From: Chuck Jett [cjett@scpw.org]
Sent: Monday, November 29, 2004 3:29 AM
To: Morris, John R.
Cc: Petro, Stephanie; Pelz, Susan; Morgan, Steve; jmillar@pbsj.com; 'Miriam Zimms'; envirosvcs4you@aol.com; 'Jose Rivera'
Subject: Landfill gas monitoring report

RE: Sumter County Solid Waste Management Facility
OGC Case No. 04-0131
FDEP Review Comments Regarding "Preliminary Contamination Assessment Plan"

TO: Stephanie Petro *usp 6/17/04*
FROM: John R. Morris, P.G. *JRM*
DATE: June 15, 2004
SUBJECT: Sumter County Solid Waste Management Facility
OGC Case No. 04-0131
Review Comments Regarding "Preliminary Contamination Assessment Plan"
cc: Susan Pelz, P.E. *SP*

DRAWING: MONITORING WELL MAP
CLIENT: S.C.B.C.C.
COMPOST FACILITY
FOR NO.: 021100.020
SHEET: 01

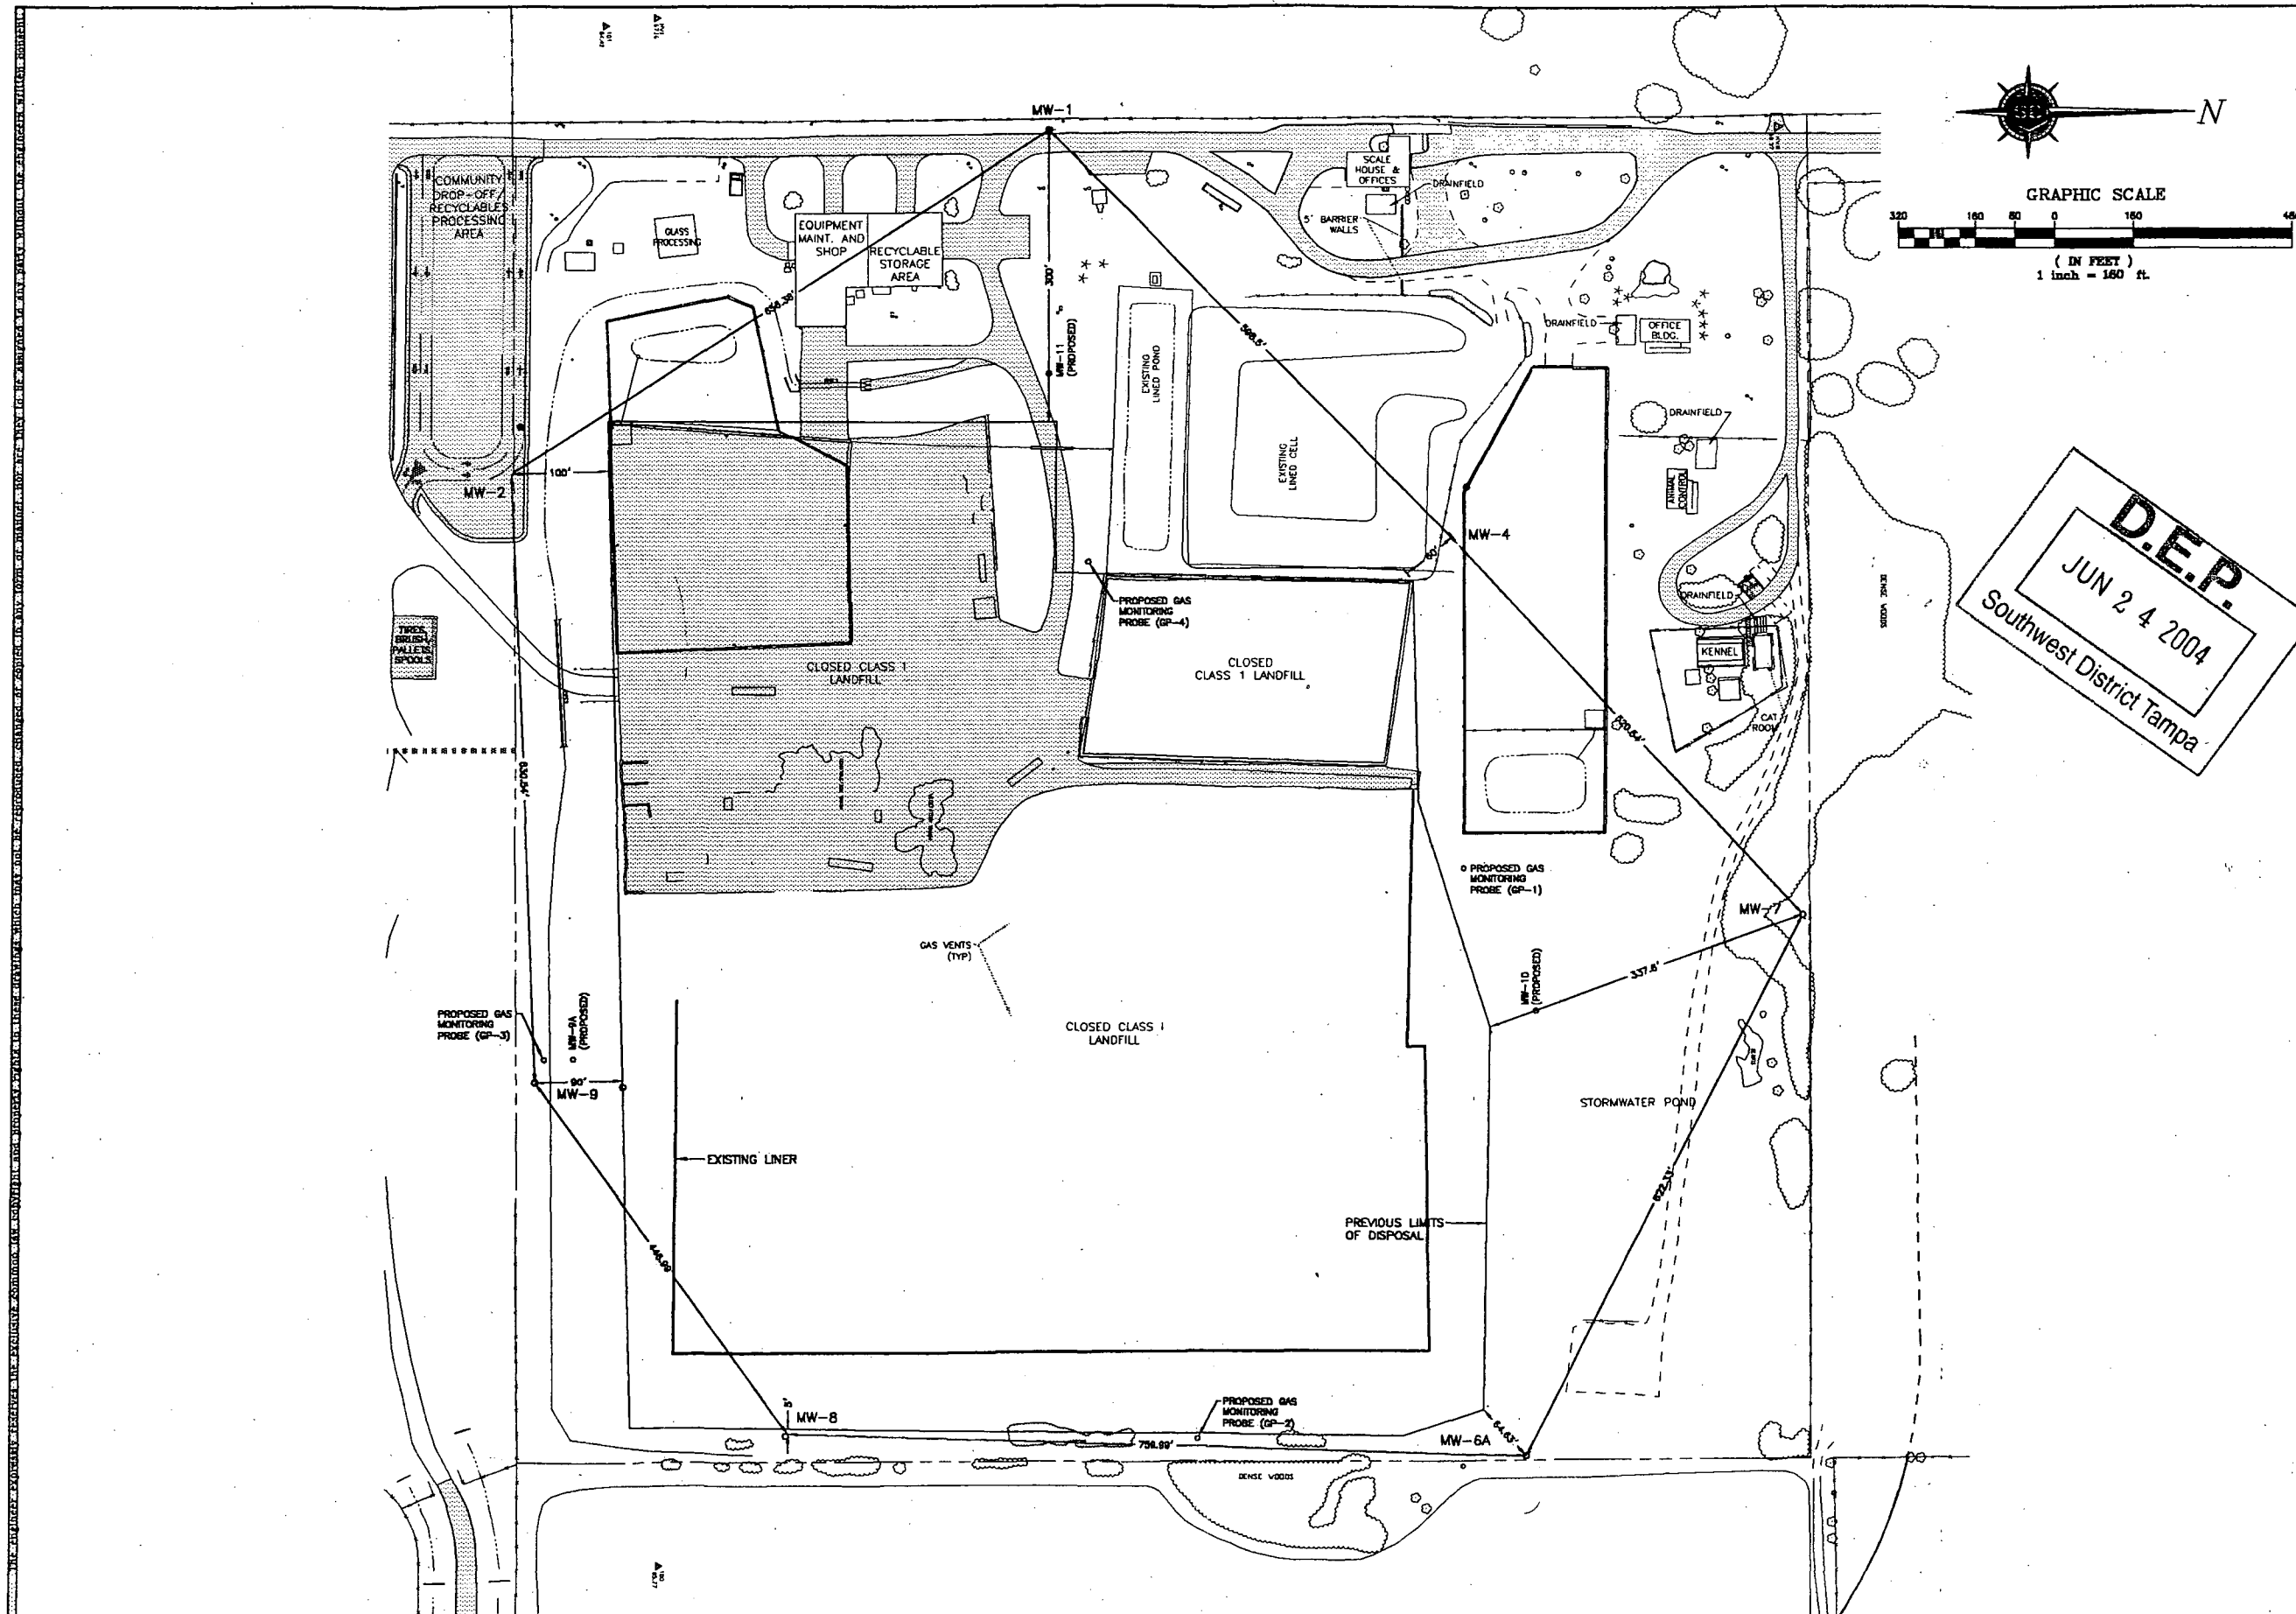
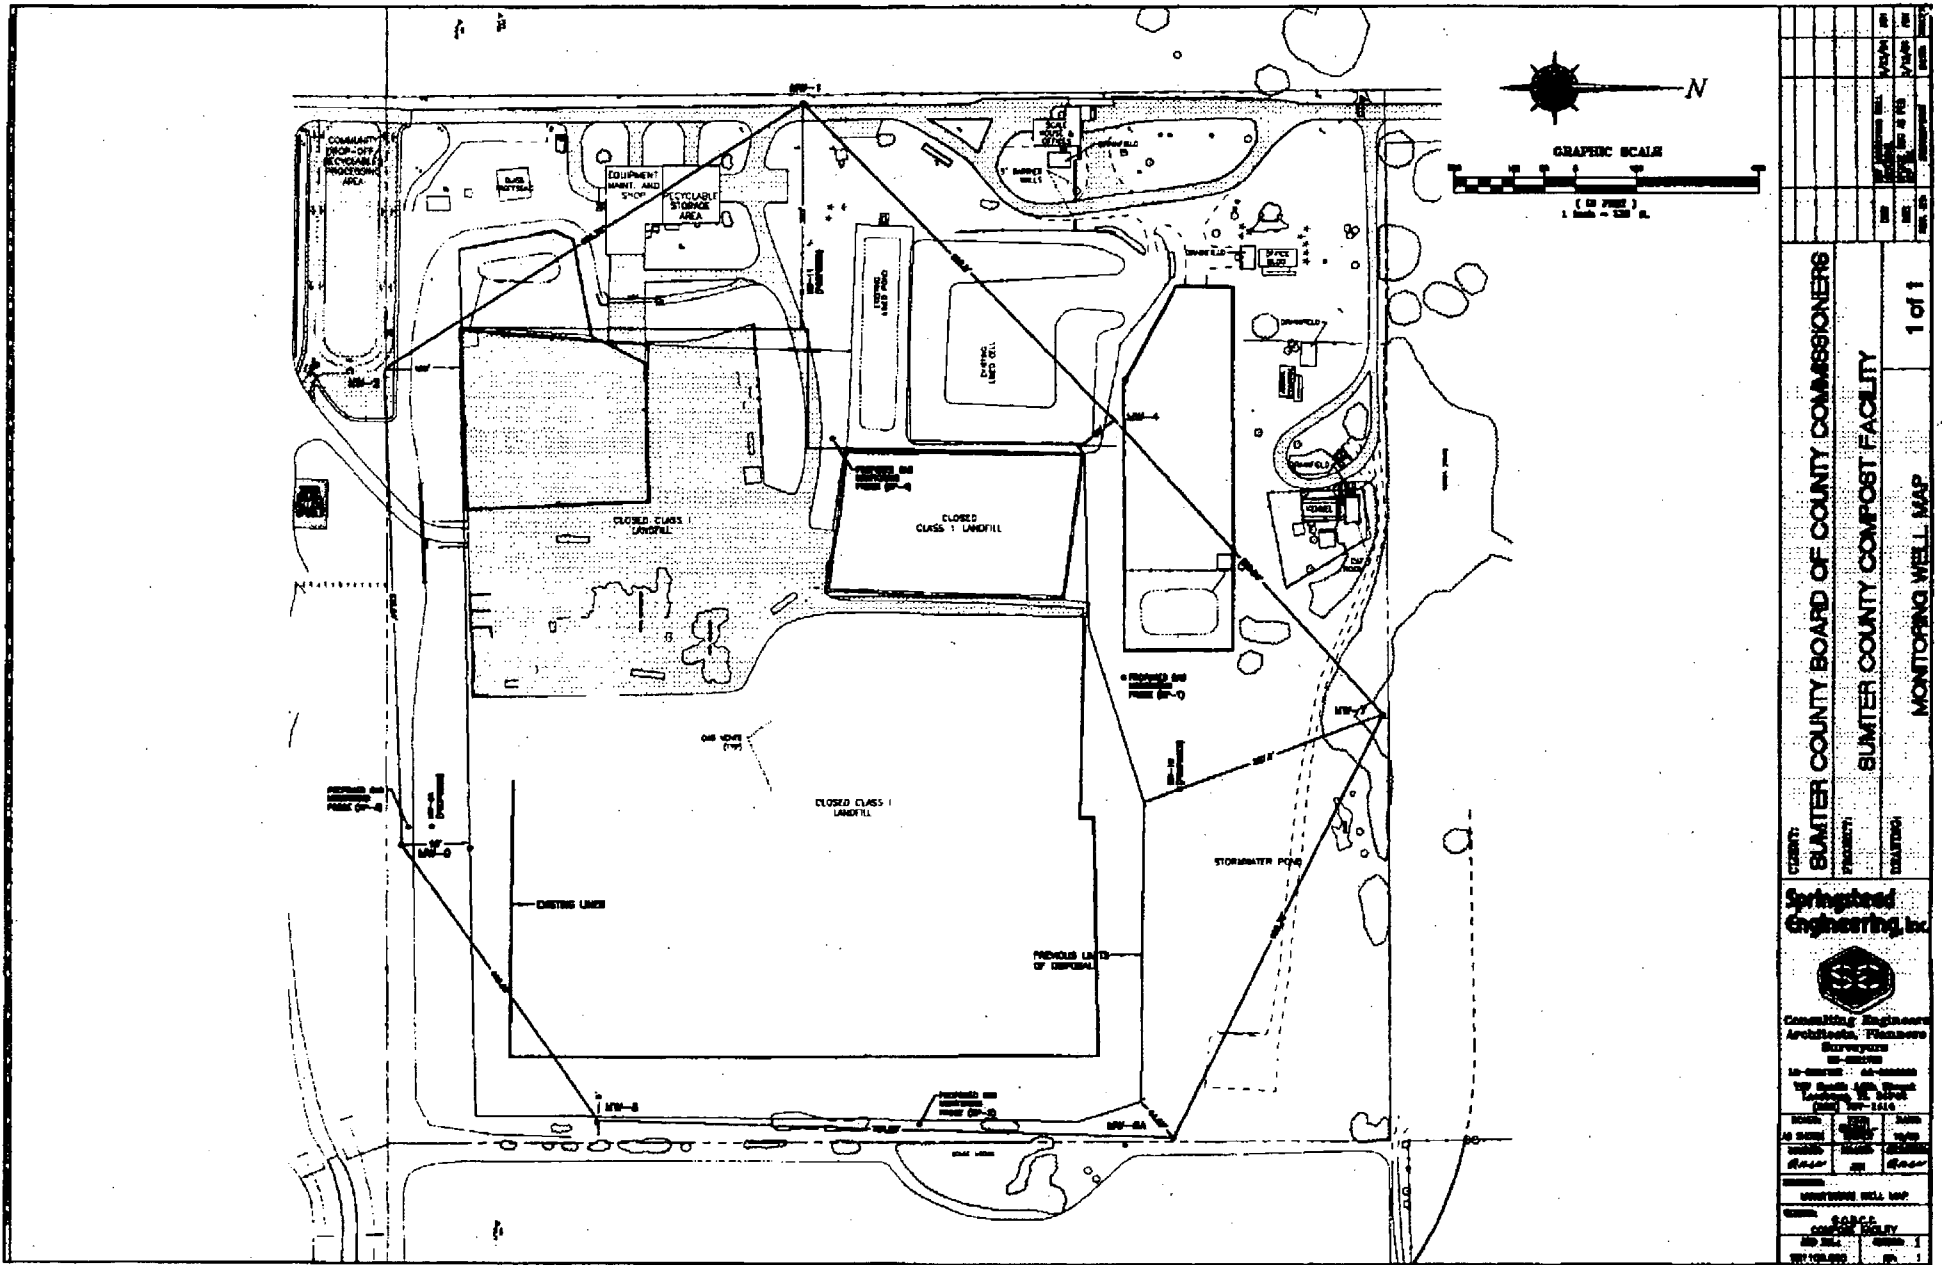
a. Installation of gas probes GP-1 through GP-4 as shown on Figure 1 entitled "Monitoring Well Map", prepared by SEI, received June 24, 2004, (attached) shall be completed **within 90 days of permit issuance** in accordance with the construction details provided on the figure entitled "Typical Gas Monitoring Probe", prepared by SEI, received Feb. 2, 2004 (attached). An initial monitoring of gas probes GP-1 through GP-4 shall be conducted **within seven (7) days of installation** and the results shall be submitted to the Department **within seven (7) days of monitoring**. New gas probes GP-1 through GP-4 shall also be included in the annual monitoring events.

15. Ground Water Monitor Well Locations. The ground water monitor wells shall be located as shown on Figure 1 entitled "Monitoring Well Map", prepared by SEI, received June 24, 2004 (**attached**), as follow:

**SUMTER COUNTY
CLOSED CLASS I LANDFILL
SITE PLAN**
FIGURE 1

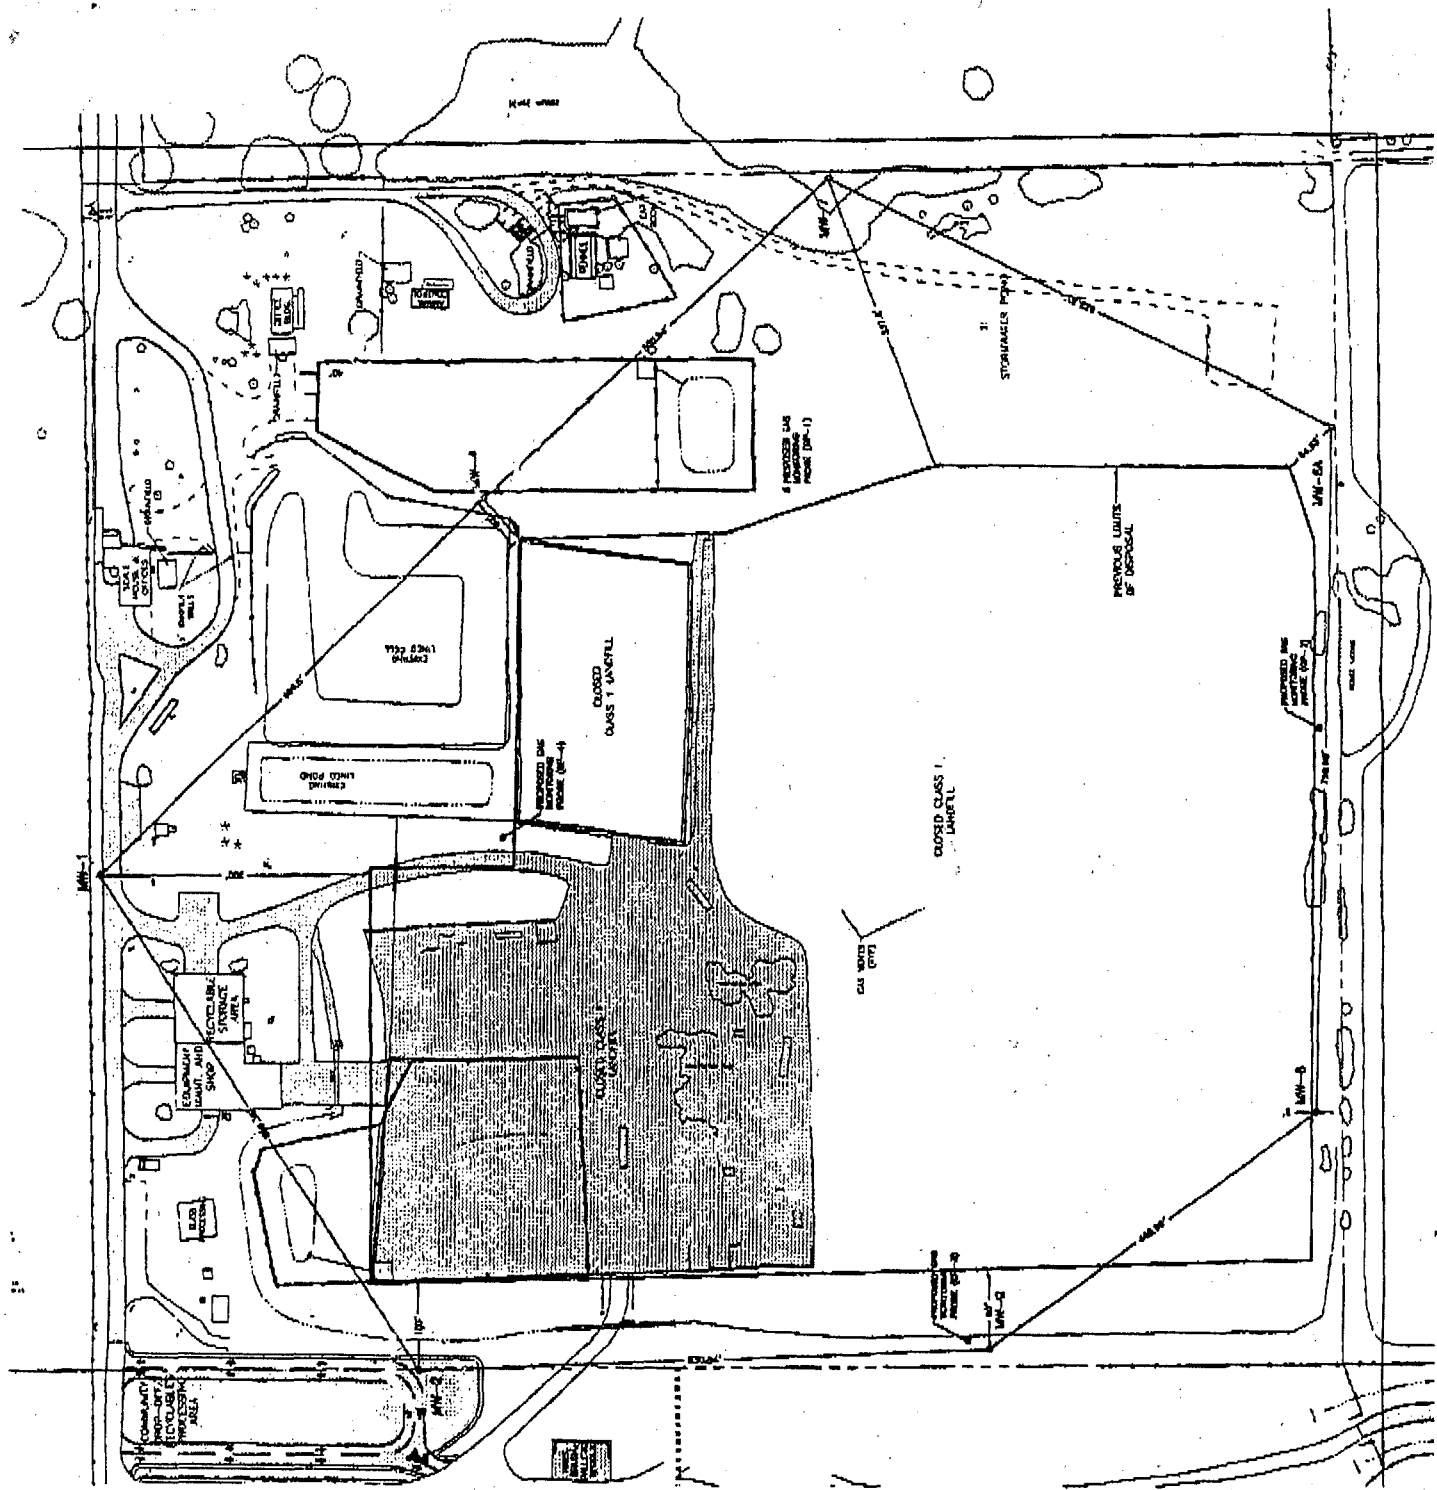
3. It is indicated that one proposed monitor well will be installed downgradient from well MW-2 and one proposed monitor well will also be installed downgradient from well MW-4, however the lateral distances are not described in relation to the zone of discharge. Please submit revisions to this section of the PCAP to provide a more complete description of these two proposed monitor well locations.

4. It is indicated that one proposed monitor well will be installed between existing well MW-4 and the known septic tanks used at separate County facilities located immediately north of the well. Review of Figure 1 indicates that septic tank/drain field facilities are located west (scale house and offices), northwest (office building), north-northwest (animal control) and north-northeast (kennel) of well MW-4. Please submit revisions to this section of the PCAP to provide a more complete description of this proposed well location and the rationale describing the adequacy of installing one well to characterize potential ground water impacts from these four septic tank/drain field areas. In the event that additional wells are proposed to be installed between well MW-4 and these septic tank/drain field areas, please submit revisions to this section of the PCAP, as appropriate.
